Community perspective on Rutherford Avenue and Sullivan Square Design Project

City Square to Austin Street – Surface Option

PROPOSED RUTHERFORD AVENUE
AT GRADE OPTION
CHARLESTOWN, MASSACHUSETTS

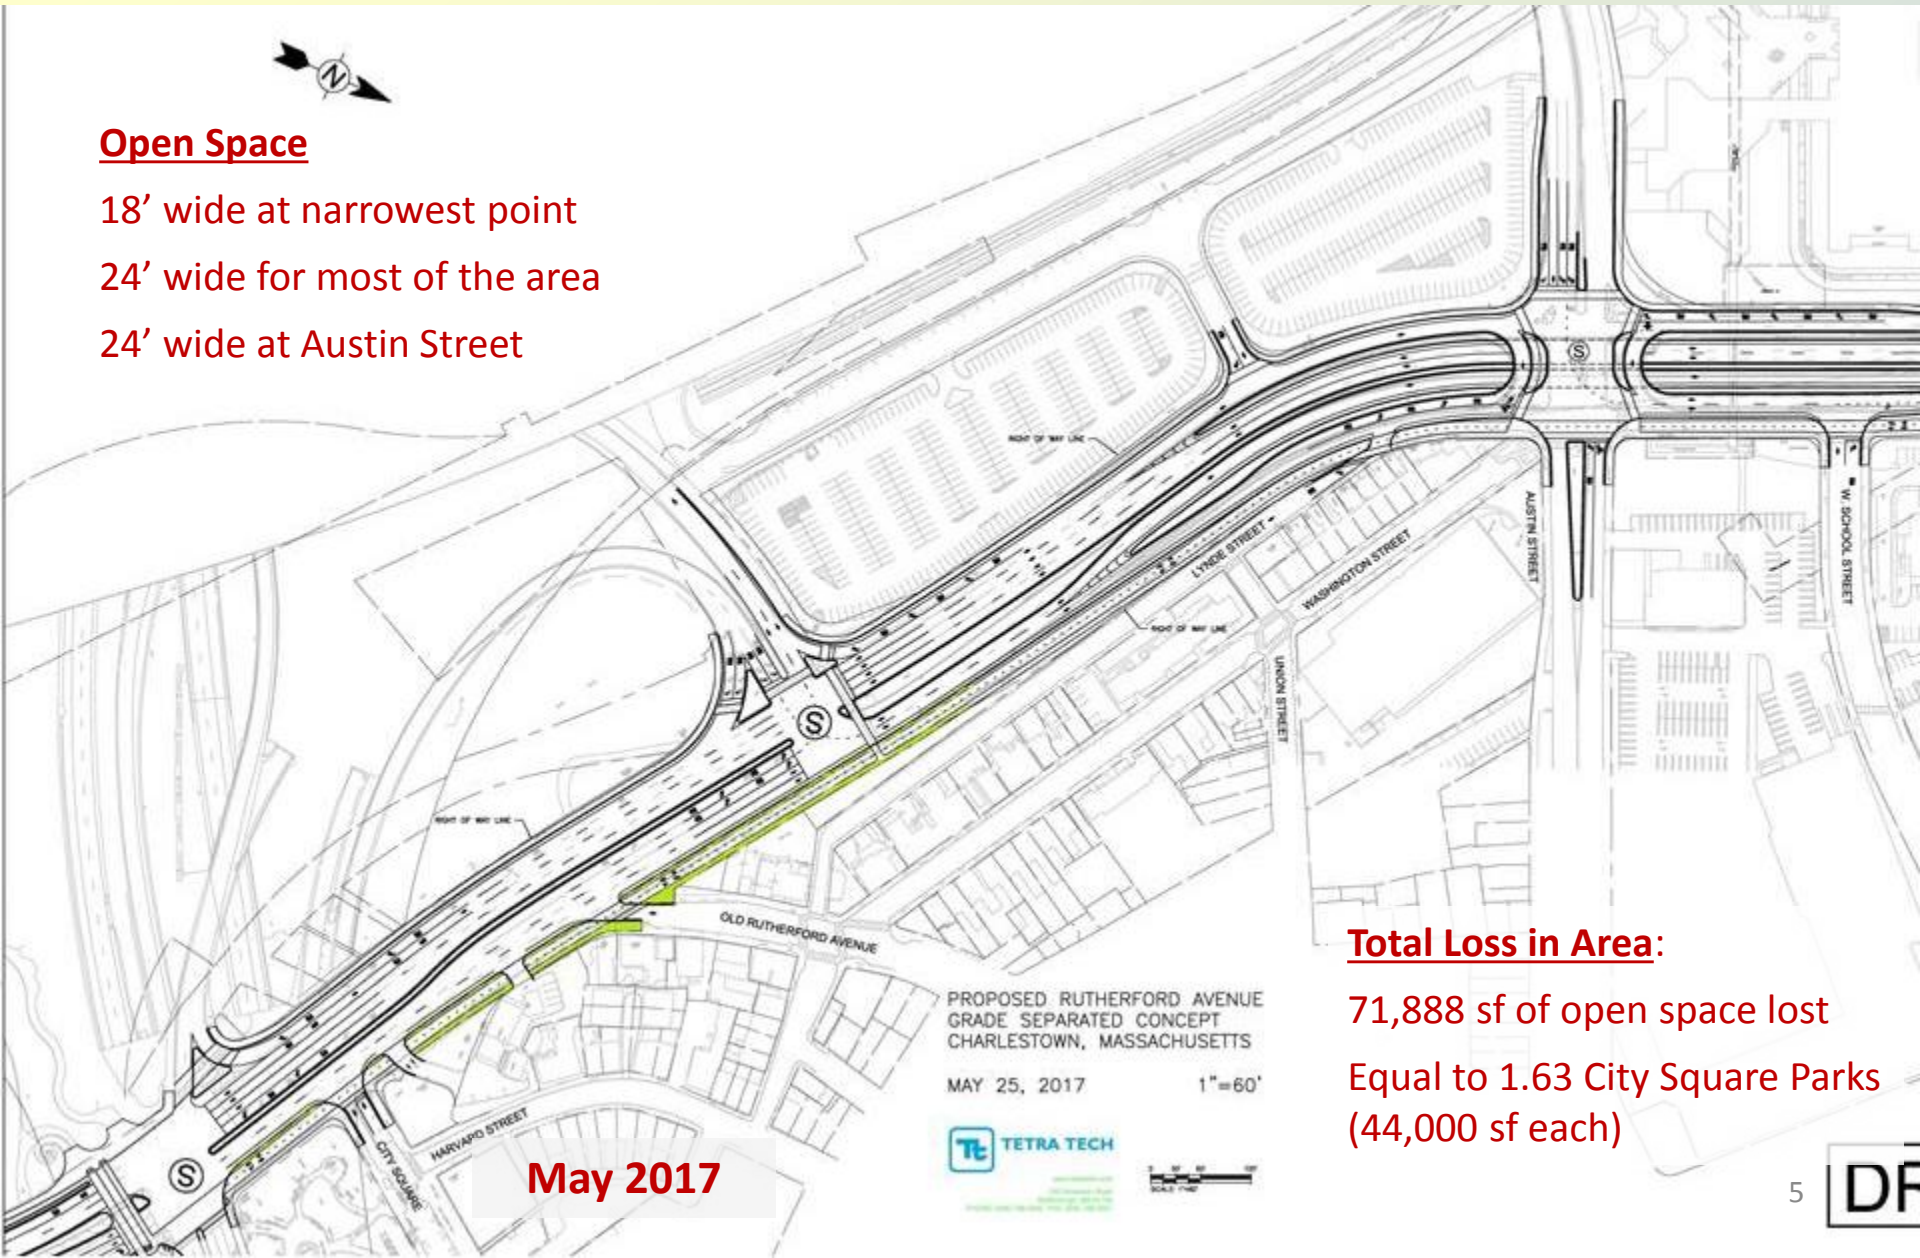
Open Space

36' wide at narrowest point

75' wide at widest point

65' wide at Austin Street

City Square to Austin Street – Underpass Option

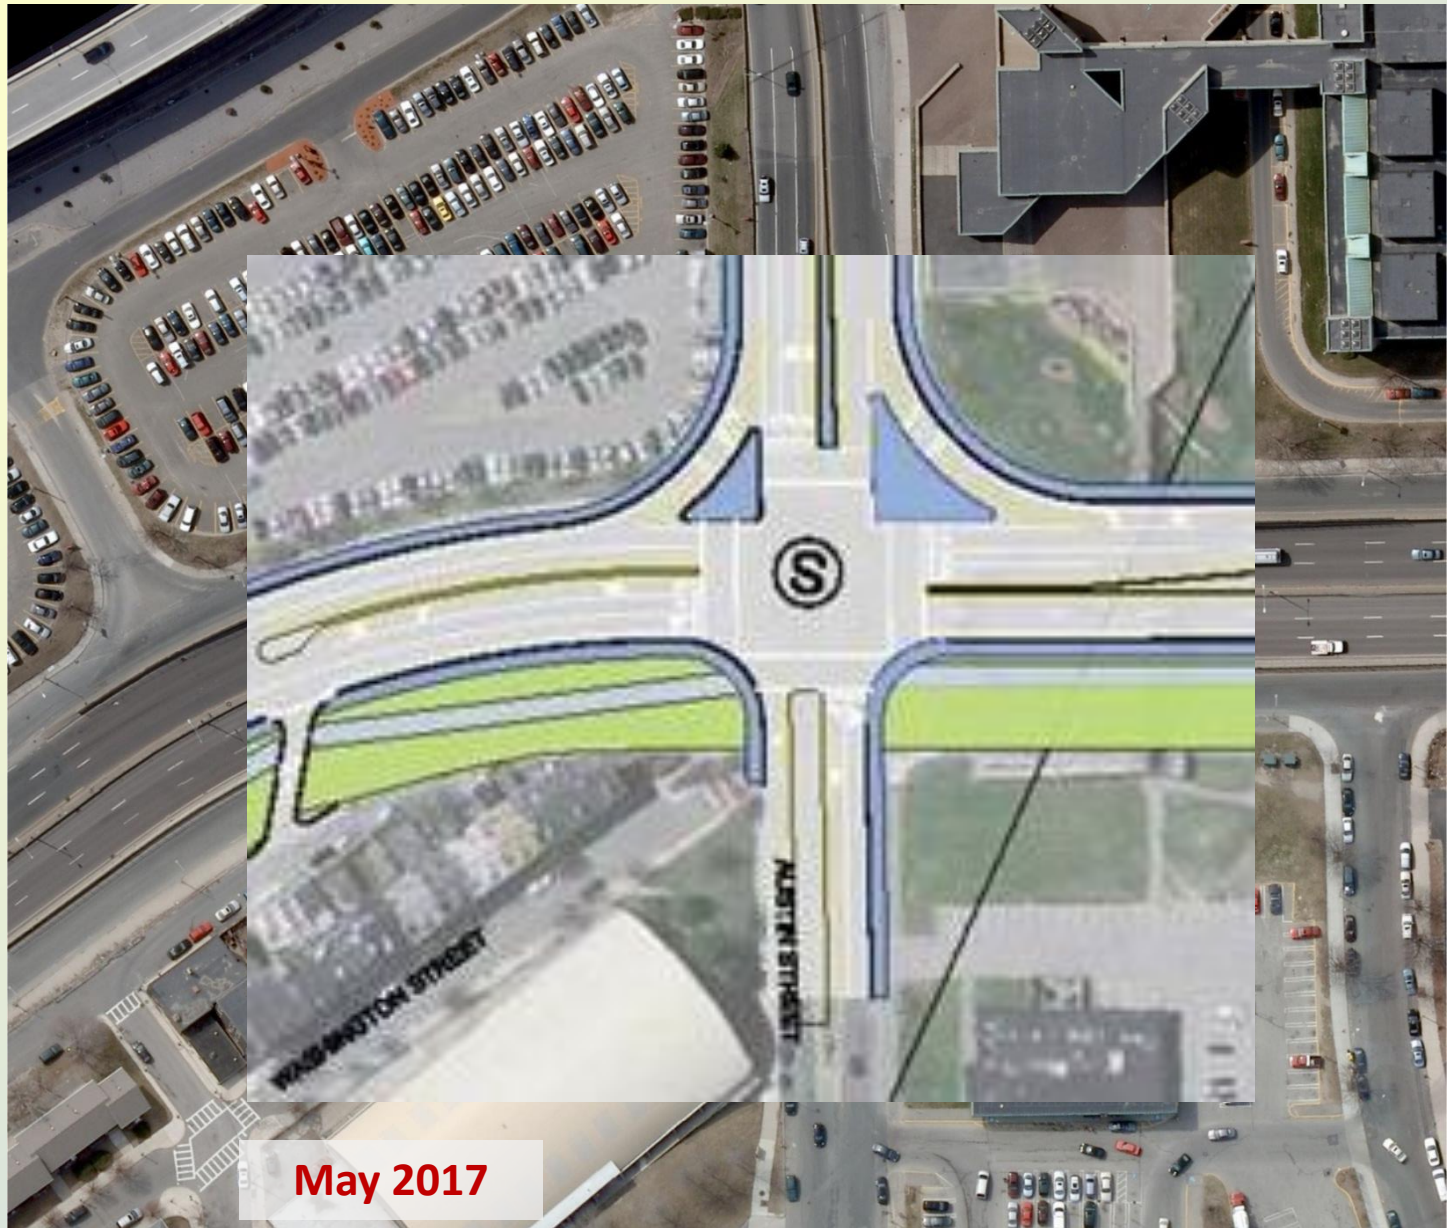
Open Space

18' wide at narrowest point

24' wide for most of the area

24' wide at Austin Street

Total Loss in Area:

71,888 sf of open space lost

Equal to 1.63 City Square Parks
(44,000 sf each)

Essex to Mishawum Street – Underpass Option

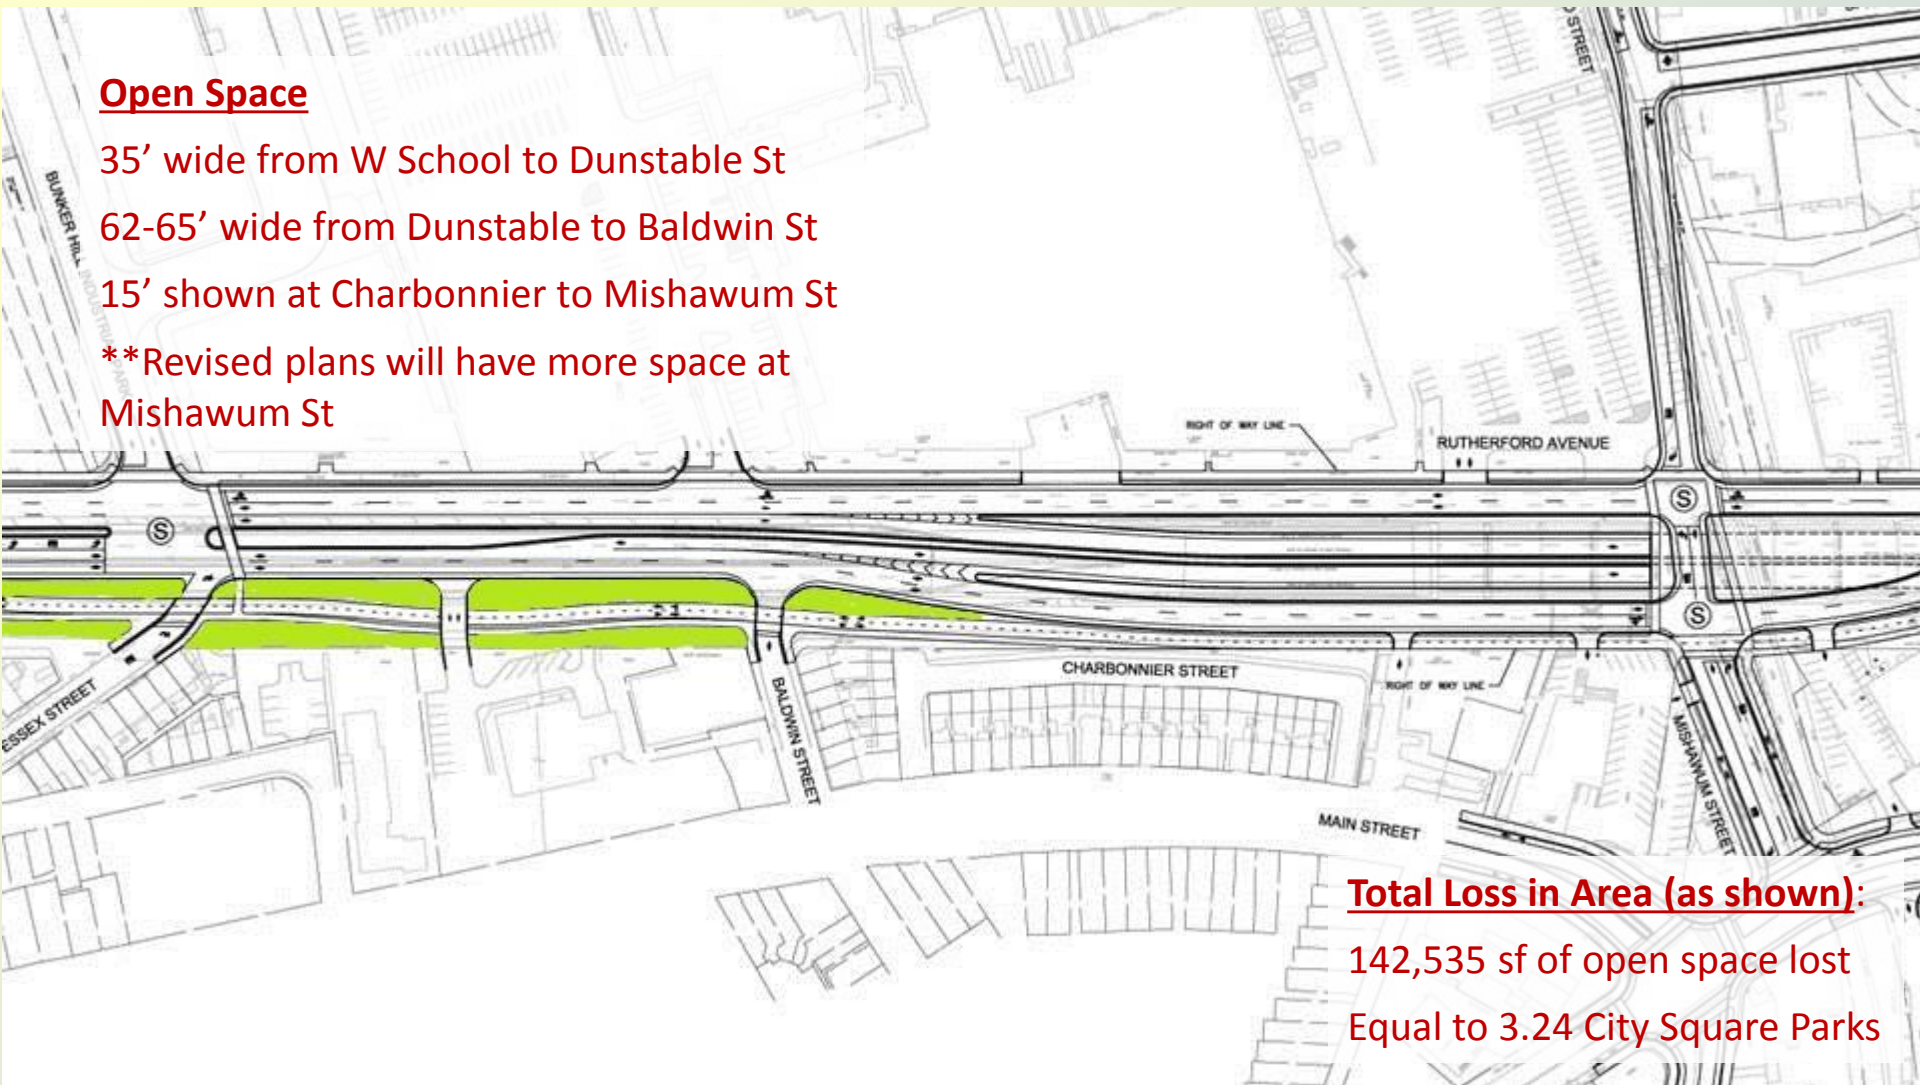
Open Space

35' wide from W School to Dunstable St

62-65' wide from Dunstable to Baldwin St

15' shown at Charbonnier to Mishawum St

**Revised plans will have more space at
Mishawum St

Total Loss in Area (as shown):

142,535 sf of open space lost

Equal to 3.24 City Square Parks

Sullivan Square – Surface Option

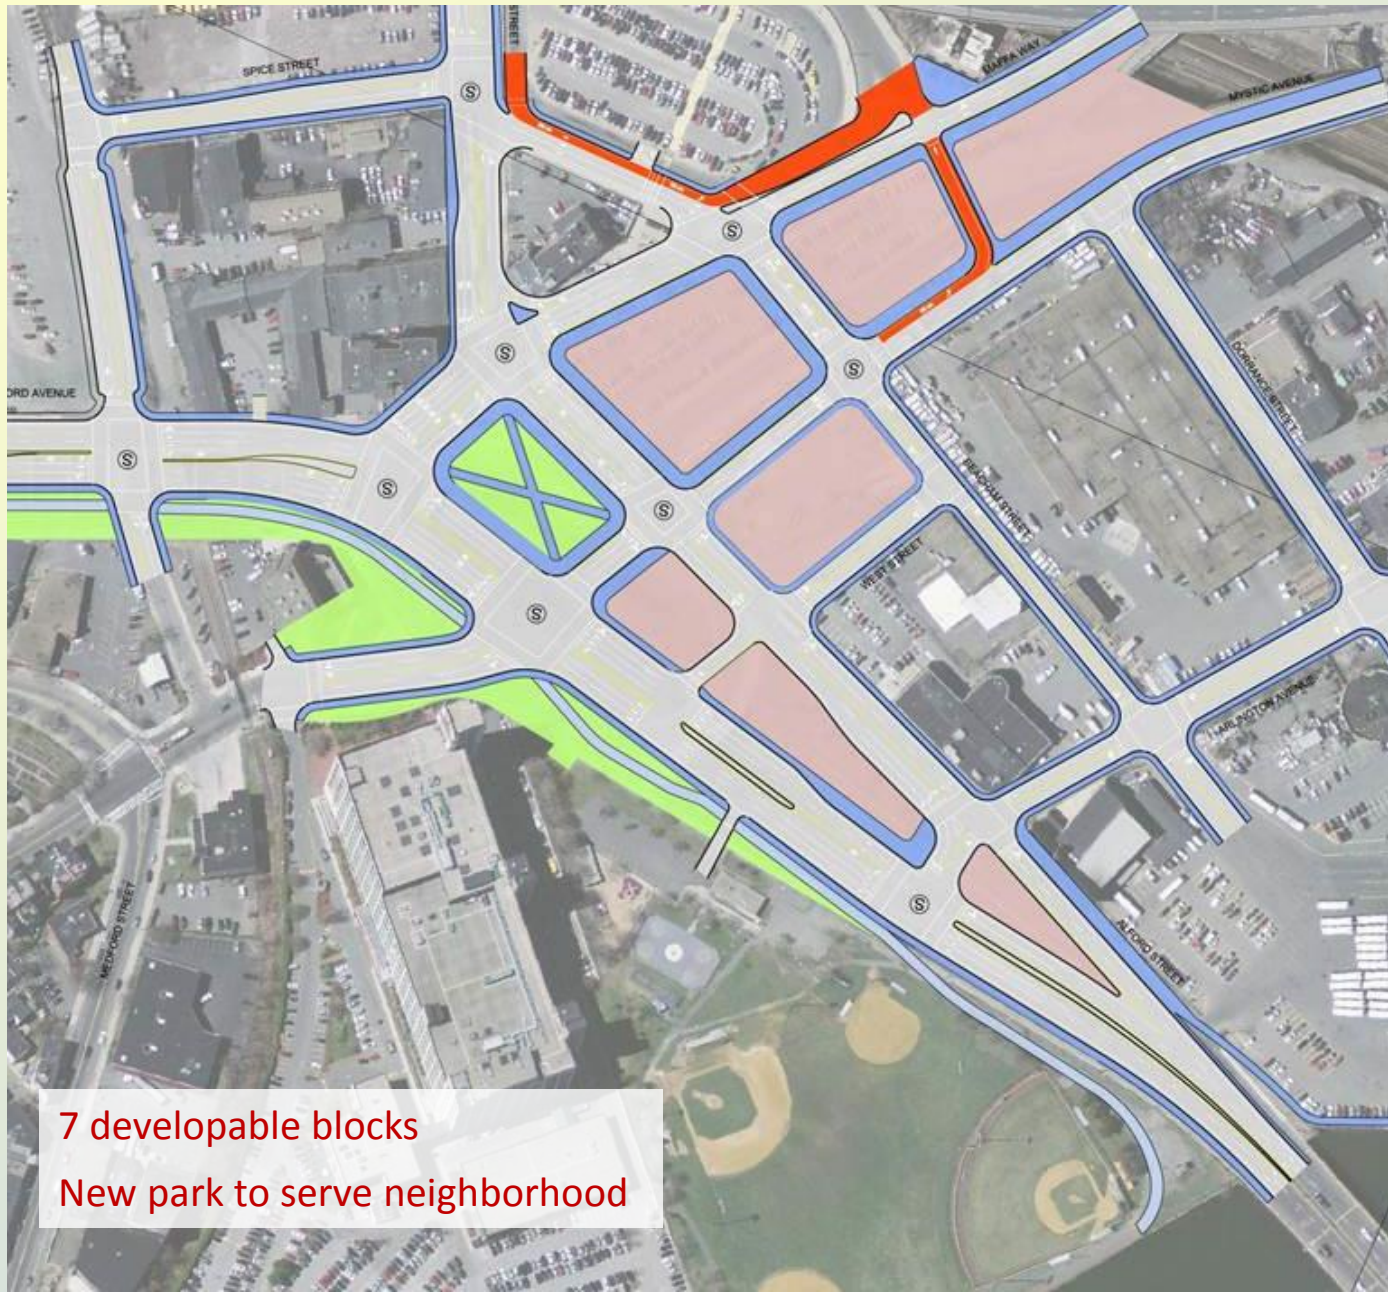
7 developable blocks

New park to serve neighborhood

Underpass Option Developable Sites

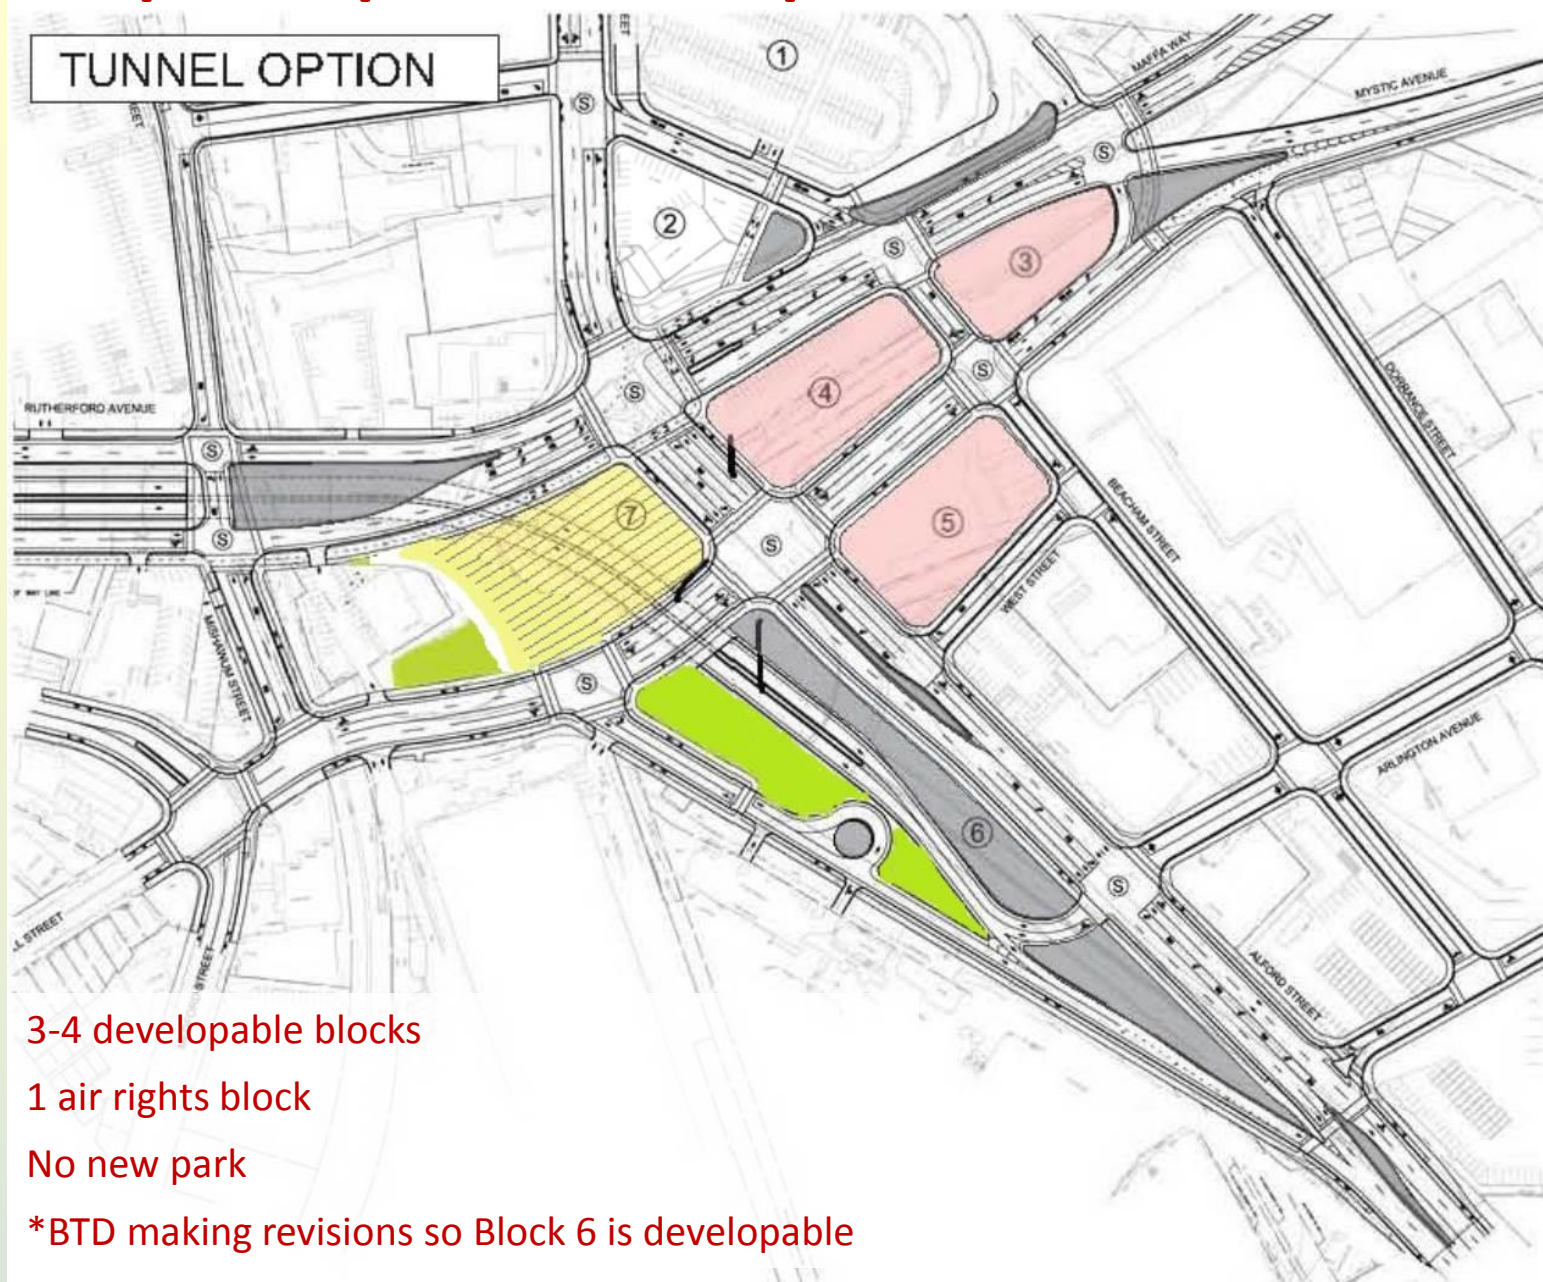
3-4 developable blocks

1 air rights block

No new park

*BTD making revisions so Block 6 is developable
